SUBJECT: Forwards addl info re mod to main feedwater lines to steam
 generators D2/D3, to alleviate certain forward flushing
 transients, per NRC 830218.

Re: McGuire Nuclear Station, Unit 1
Docket No. 50-369
D2/D3 Steam Generator Design Modification

DUKE POWER COMPANY
McGUIRE NUCLEAR STATION, UNIT 1
D2/D3 STEAM GENERATOR DESIGN MODIFICATION
RESPONSE TO REQUEST FOR ADDITIONAL INFORMATION

FIGURE CAPA-2

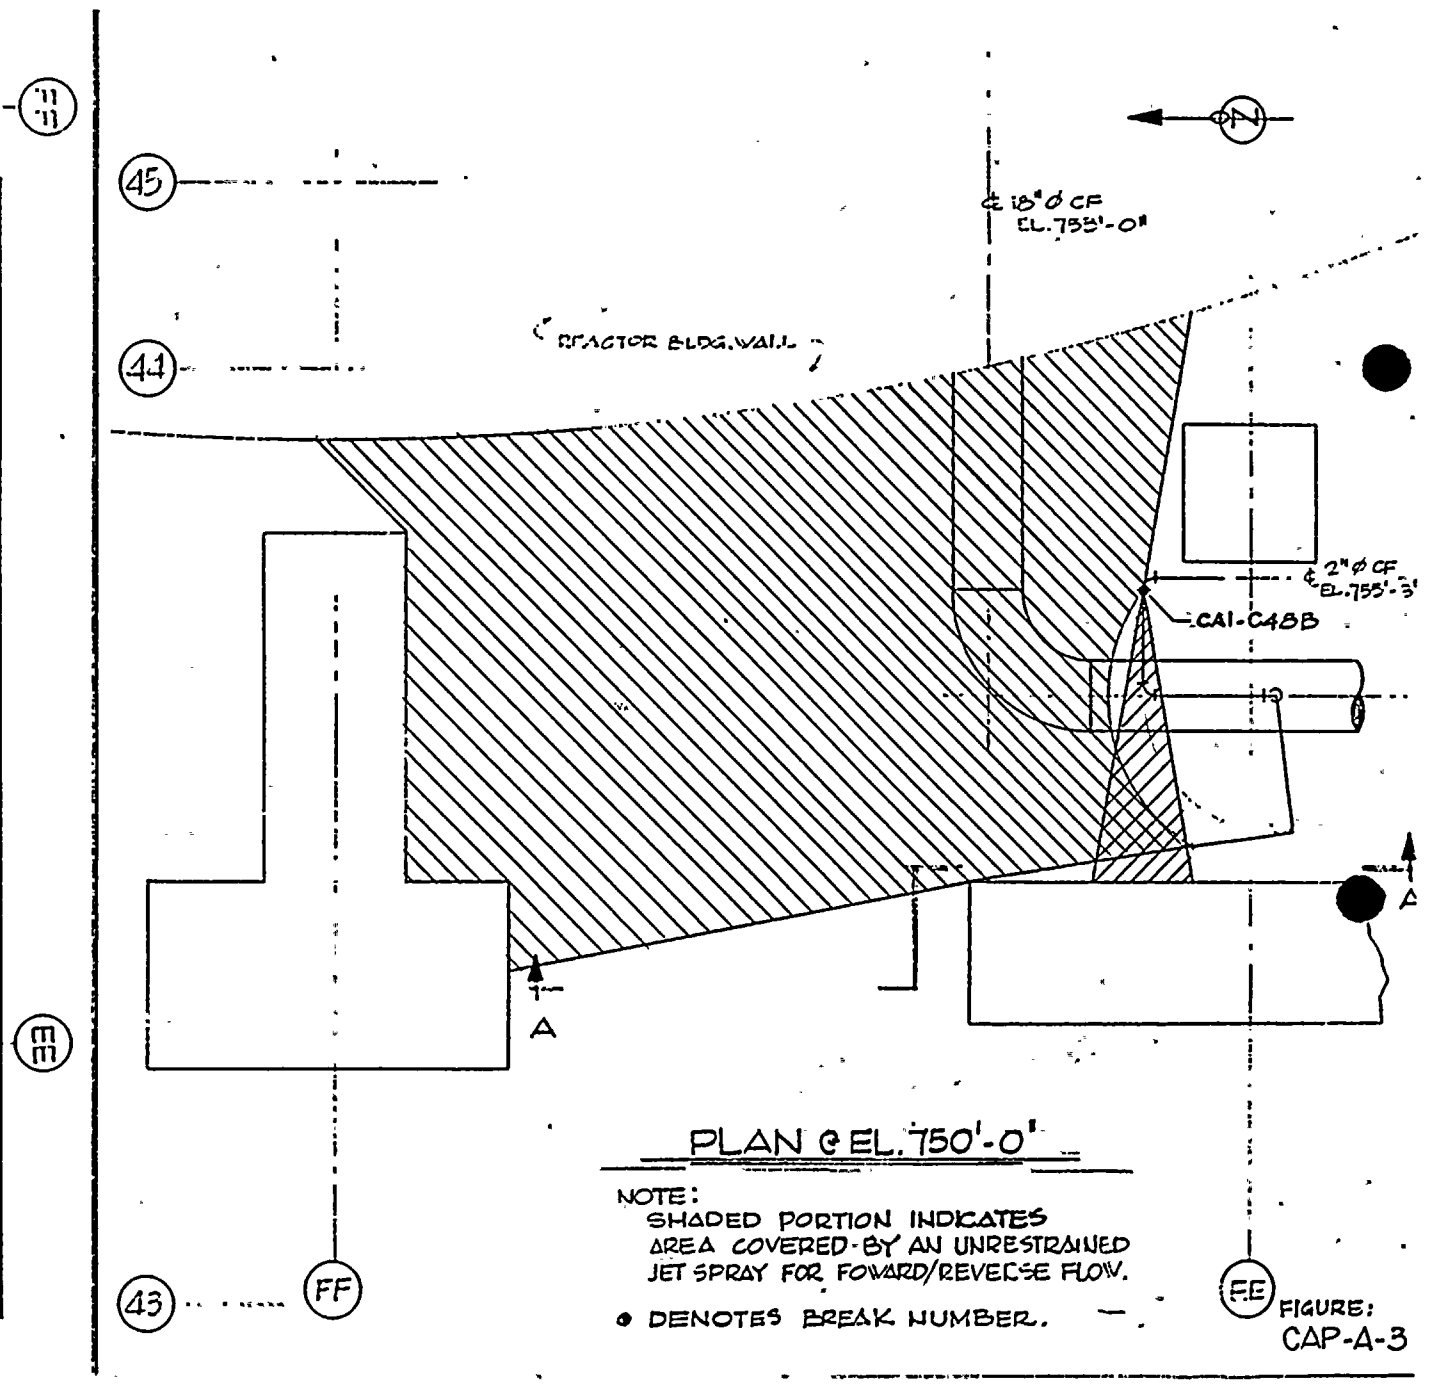
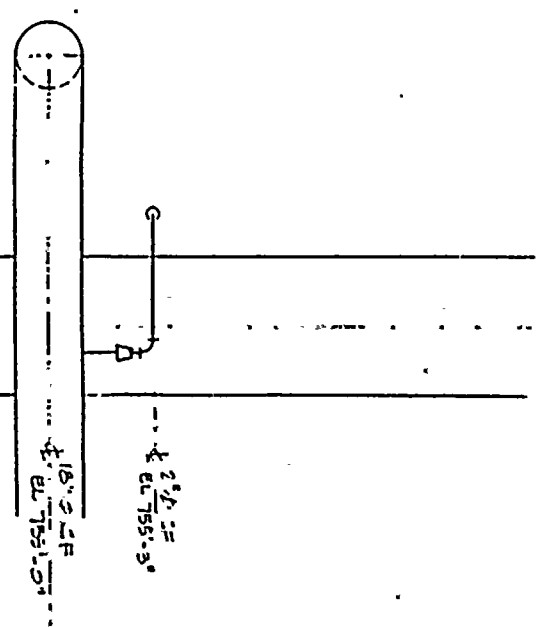
8. Q. Since the piping valves will be subjected to a temperature higher than 200°F or a pressure greater than 275 psig, provide the results of a high energy pipe break analysis in accordance with the Standard Review Plan Section 3.6.1. Provide drawings which show the piping configurations, postulated break locations, the jet cones which result from the escaping fluid, and the location of the pipe whip restraints. For those portions of the proposed system which do not have a temperature higher than 200°F and do not have a pressure greater than 275 psig, provide the results of the moderate energy pipe crack analysis in accordance with the acceptance criteria of Standard Review Plan Section 3.6.1.

Figures CAP-A-1 thru 4 and CAO-D-1 & 2 provide the jet cones which result from the escaping fluid issuing from the new break locations requiring protective devices.
